Mobile Intel® Pentium® 4 Processor-M

Specification Update

September 2003

Document Number: **250721-018**

Figure 13. System Bus Reset and Configuration Timings

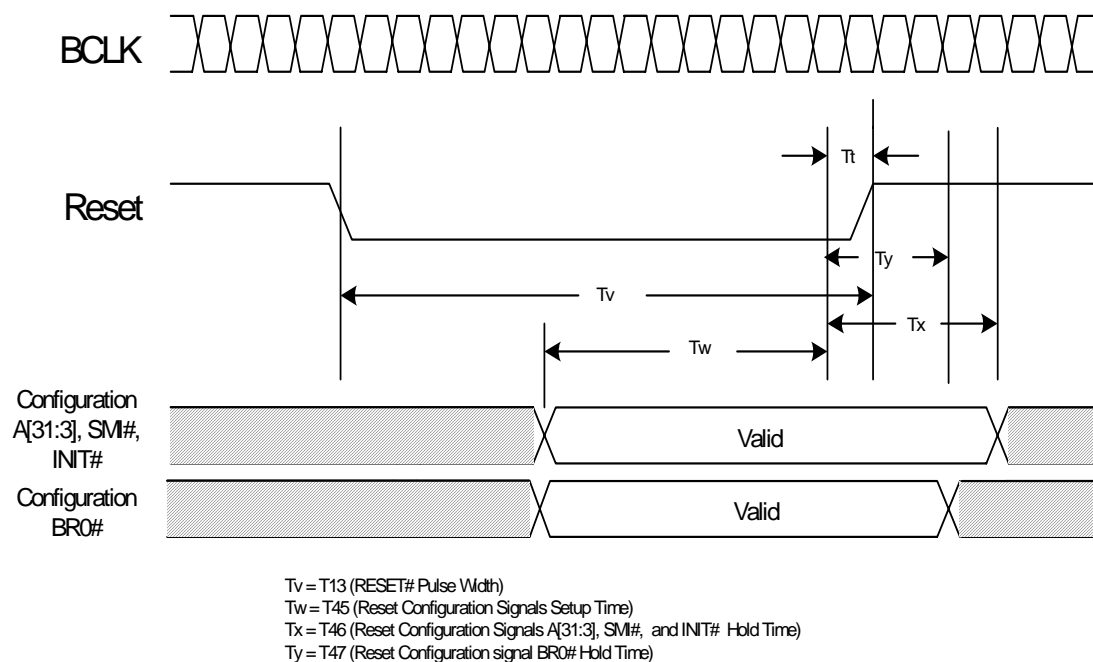
T2. BR0# Maximum Hold Time Specification Change

The BR0# maximum hold time has changed to 2 BCLKs. This change will be shown in the “System Bus AC Specifications (Reset Conditions)” table and “System Bus Reset and Configuration Timings” figure of the *Mobile Intel® Pentium® 4 Processor - M Datasheet*. This change will be incorporated in the next revision of the datasheet.

The following figure will be modified to reflect this change:

T# Parameter	Min	Max	Unit	Figure	Notes
T45: Reset Configuration Signals (A[31:3]#, BR0# INIT#, SMI#) Setup Time	4		BCLKs	13	1
T46: Reset Configuration Signals (A[31:3]#, INIT#, SMI#) Hold Time	2	20	BCLKs	13	2
T47: Reset Configuration Signal BR0# Hold Time	2	2	BCLKs	13	2
